Application No: 23/4152M

Location: The Dam Embankment of Poynton Pool Reservoir, Poynton Park, London Road North (B5092), Poynton

Proposal: The proposed removal of low points along approximately 480m of the Poynton Pool dam embankment and slightly raising the level of crest to increase the flood resilience of the reservoir. A kerb alongside an enhanced footpath will create the crest level and the works will also include the creation of two 40m wide clearings, to further increase flood resilience.

Anglesey Drive properties

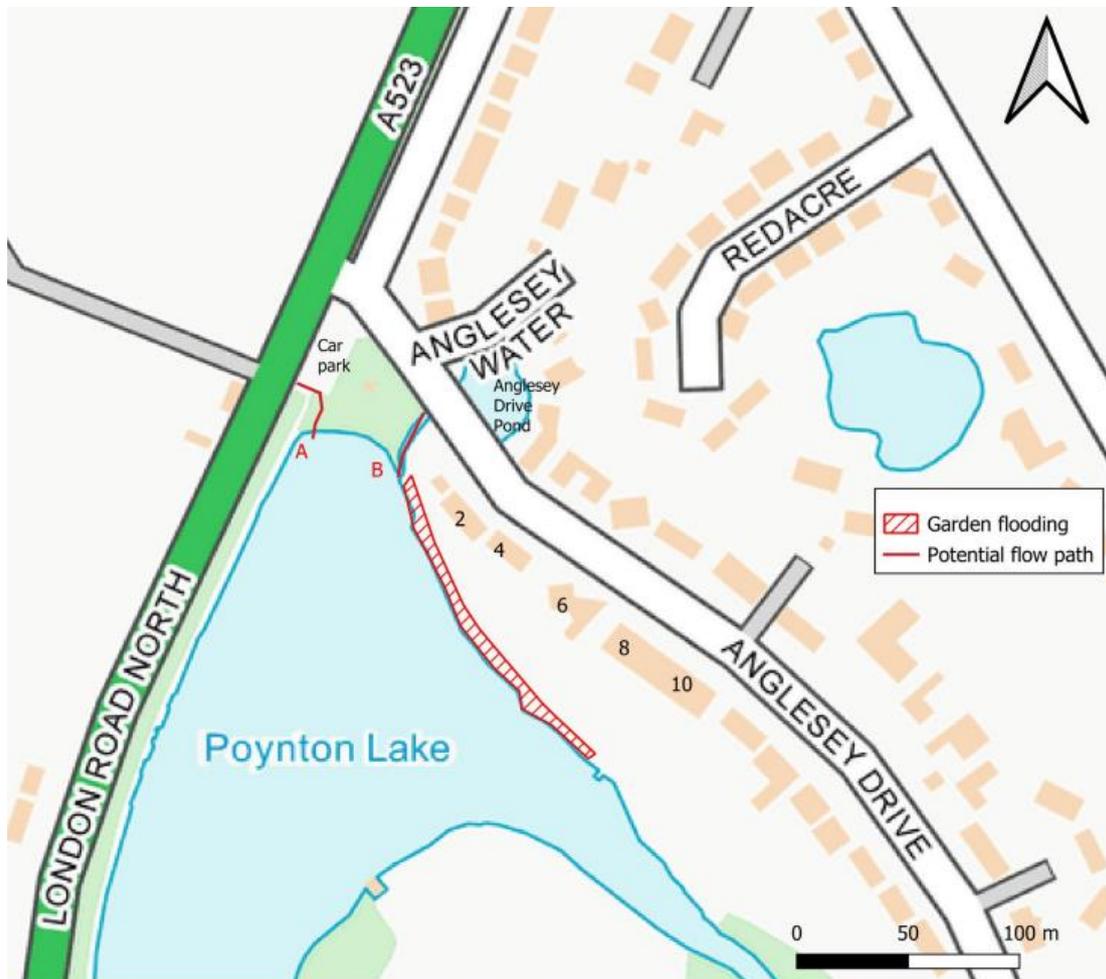
Policy SE13 states that FRAs should be submitted to demonstrate that development proposals will not increase flood risk on site or elsewhere. Flood risk is a combination of the probability (likelihood or chance) of an event happening and the consequences (impact) if it occurred. Following the proposed works the frequency and peak flow overtopping of the dam to the west of the pool is expected to decrease as a result of the proposed works, reducing flood risk downstream (to the west). However, it does appear that flood risk will increase to the properties to the north along Anglesey Drive. Whilst these are gardens that are likely to flood in the 0.01% AEP event, it is still disappointing that mitigation is not provided for these properties as part of the proposals when the modelling suggests that the proposed development will increase the flood levels in their gardens during these events.

The image below shows the extent of the area affected to the rear of the properties along Anglesey Drive. The image also shows two potential flow paths (Route A via the car park and Route B towards Anglesey Drive pond). Flow path A will be addressed by the raising of the crest level along the western dam. Flow path B is the route of a ditch which connects Anglesey Drive pond and the reservoir. The FRA states that the nature of the connection between the ditch and Poynton Pool Reservoir is currently unknown however it is possible that water could flow from Poynton Pool along the ditch, under Anglesey Drive and into the pond. The ground levels along the ditch (90.89mAOD) are lower than the existing maximum flood level during the 0.01%

AEP event so the ditch is already expected to flood. The flood depths along this route are expected to increase by 0.18m as a result of the proposed works (0.3m existing flood depths compared to the proposed 0.48m flood depth). The FRA states that this could be partially mitigated by installing a flap valve on the downstream end of the culvert, to prevent the lake entering the pond, and this will be explored as part of the detailed design.

The proposed works will reduce flood risk downstream (to the west) of the reservoir, and the LLFA and the Environment Agency raise no objections to the proposal. However, given that the proposal does increase flood risk elsewhere (to the rear of 2-10 Anglesey Drive, and potentially towards Anglesey Drive pond, there is some conflict with policy SE13 of the CELPS.

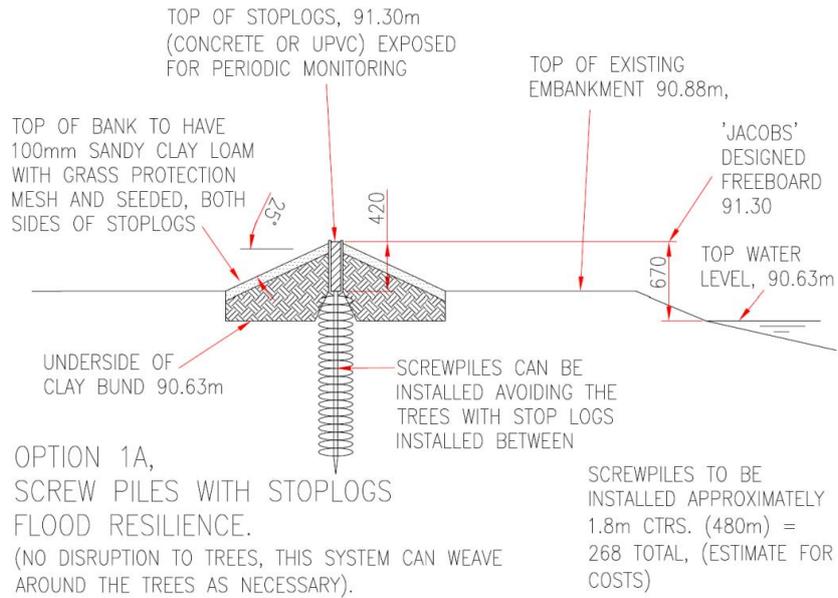
Introducing an armoured spillway as a “fail safe” – This is an auxiliary spillway similar to option 3B above. The flow would be concentrated onto the road, rather than spreading it along the 480m crest as with the proposed design. Additional works would be required to take the flow along the road to the low point and protect the adjacent houses, as concentrated water would flow into the driveways. The downstream embankment would need to be protected from overflow and works would likely be required in private gardens,

The crest of the embankment would still need to be raised to meet the wave freeboard requirement in Floods and Reservoir Safety (2015) with associated tree loss.

Option 1A Screw piles with stoplogs and clay bunds to both sides

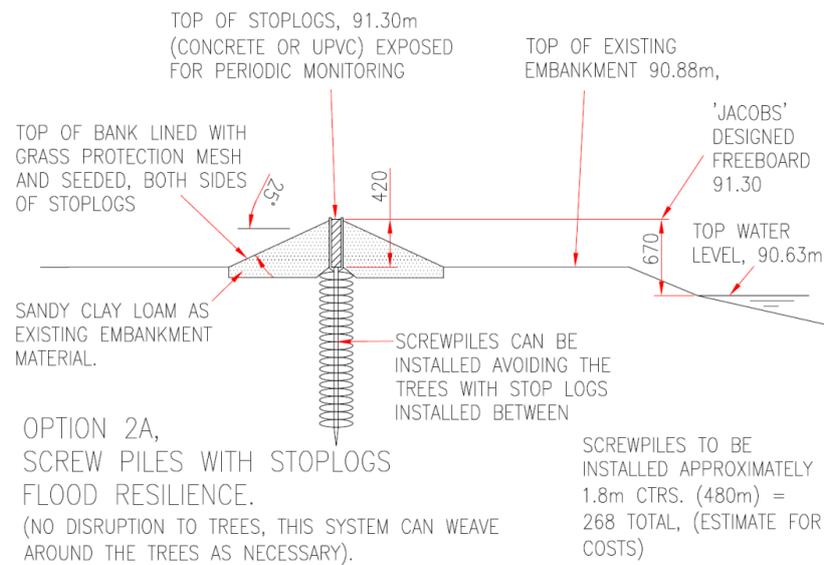
The following options have also been put forward by Friends of Poynton Pool (FoPP) in their letter of representation:

The applicant has stated that screw pile options have been considered. A Screw pile option would be more expensive and can be easily undermined by water. Tree roots would be left in place which would allow flow under the beam, which is likely to cause internal erosion and is another potential failure mode of the dam. Alterations to the roadside wall have also been considered as above.
